A/C Inoperative - Rear A/C Line Retainer Missing

Service Category Vehicle Interior

Section Heating/Air Conditioning

A/C Inoperative - Rear A/C Line Retainer Missing

Figure 1. Location of the A/C Line Retainers (Piping Clamps)

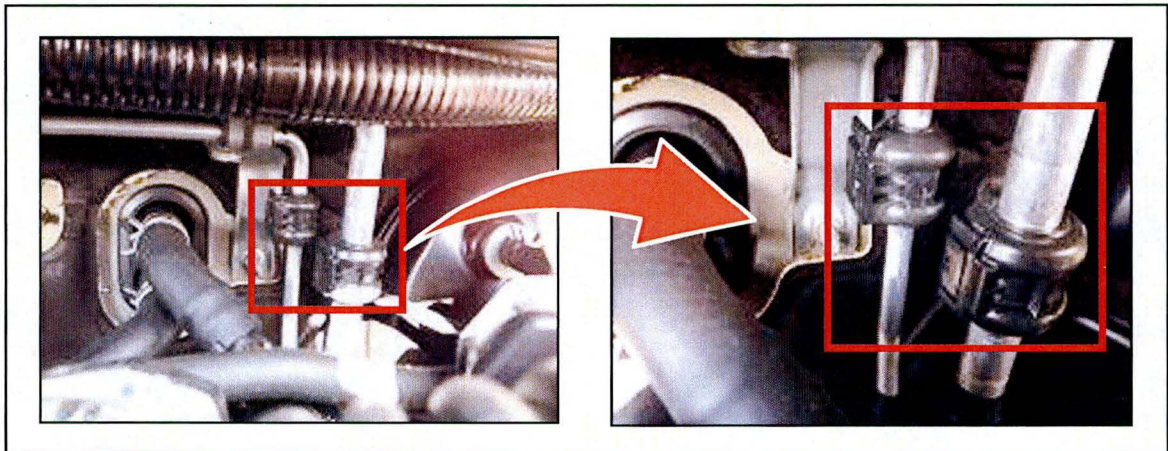
Some vehicles may exhibit a condition where there is a lack of cooling from the A/C system. An A/C Line Retainer (Piping Clamp) may have become unlatched and caused a refrigerant leak. Follow the procedure in this bulletin to address this condition.

- If the A/C Line Retainer is intact and latched, this bulletin does NOT apply. Continue diagnosis using the applicable Repair Manual.
 - If one or both of the A/C Line Retainers is missing or unlatched, proceed to step 2.
2. Recover the refrigerant following the Repair Manual instructions.

3. If the A/C Line Retainer is still present but unlatched, remove it and replace it with a NEW A/C Line Retainer.
4. If the A/C Line Retainer is missing, then install the NEW A/C Line Retainer.
5. Once the NEW A/C Line Retainer is installed, recharge the refrigerant following the Repair Manual instructions.
 - [2011 / 2012 / 2013](#) Highlander:
Vehicle Interior – Heating/Air Conditioning – “Air Conditioning: Refrigerant: Replacement”
 - [2011 / 2012 / 2013](#) Sequoia:
Vehicle Interior – Heating/Air Conditioning – “Air Conditioning: Refrigerant: Replacement”
 - [2011 / 2012 / 2013](#) Sienna:
Vehicle Interior – Heating/Air Conditioning – “Air Conditioning: Refrigerant: Replacement”
6. Verify the A/C operates normally.
